APPLICATION NUMBER 10/009298	2035 FILING DATE 12/04/2001	FIRST NAME APPLICANT Scott E. Klopfenstein	ATTORNEY DOCKET NUMBER RCA 89549
---------------------------------	--------------------------------	---	-------------------------------------

Notice Regarding Drawings

NOTICE OF DRAFTSPERSON'S PATENT DRAWING REVIEW

FIG. 1

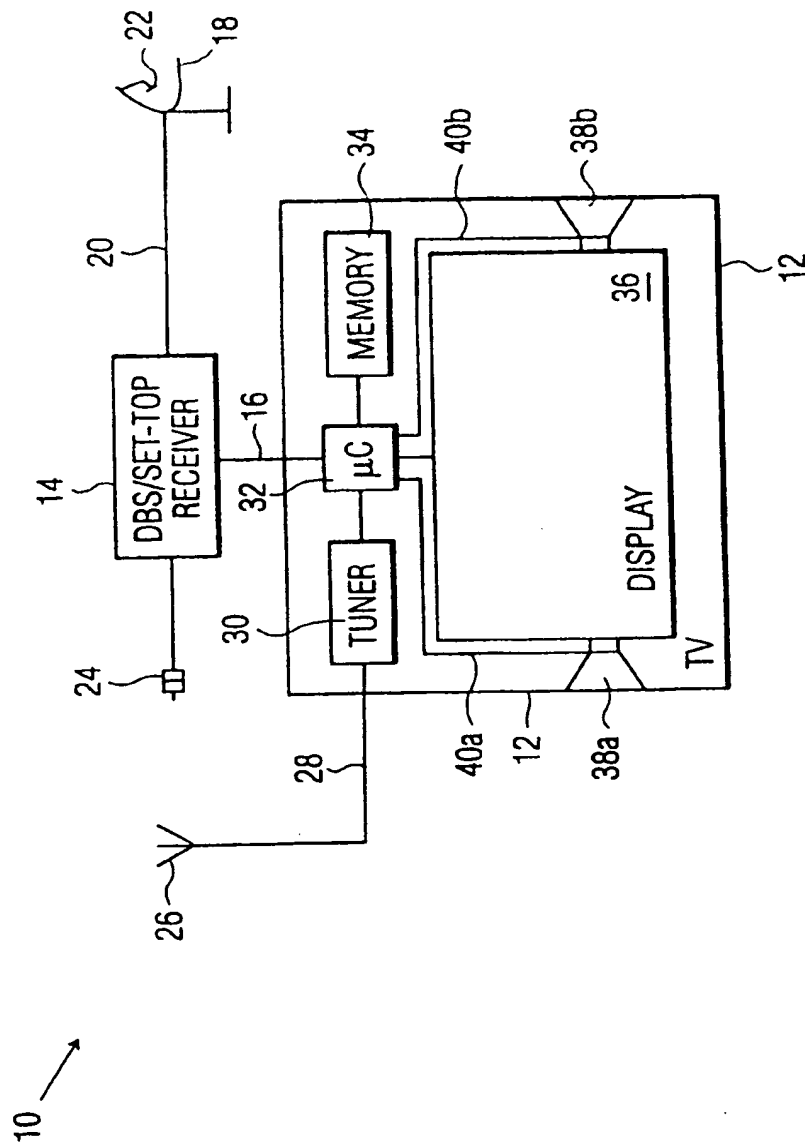
Lines, numbers & letters not uniformly thick and well defined, clean, durable, and black (poor line quality). Fig(s) 1-6

Numbers and reference characters not plain and legible. Fig(s) 1-6
 Figure legends are poor. Fig(s) _____
 Numbers and reference characters not oriented in the same direction as the view. 37 CFR 1.84(p)(1) Fig(s) _____

FIG. 2

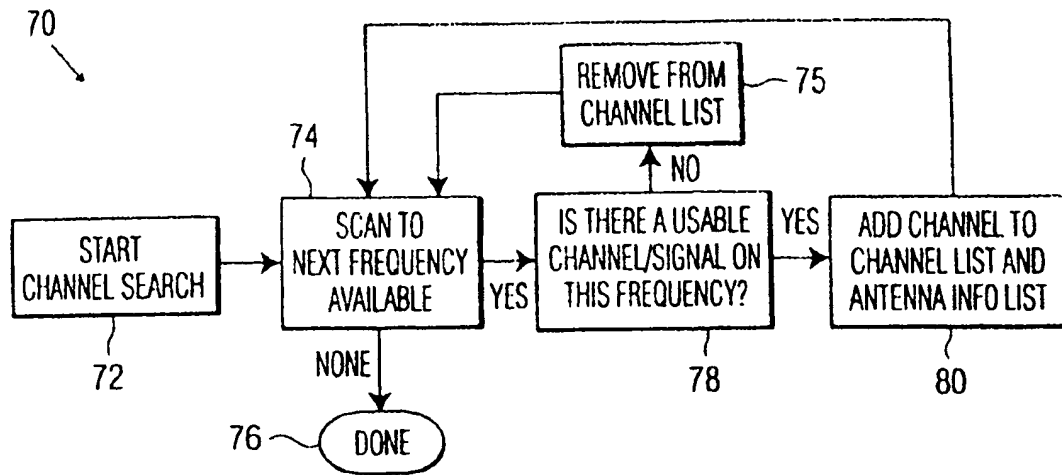
• illegal shading on (Fig. 6)
 • fig. titles on (Fig. 2-5)
 WJG
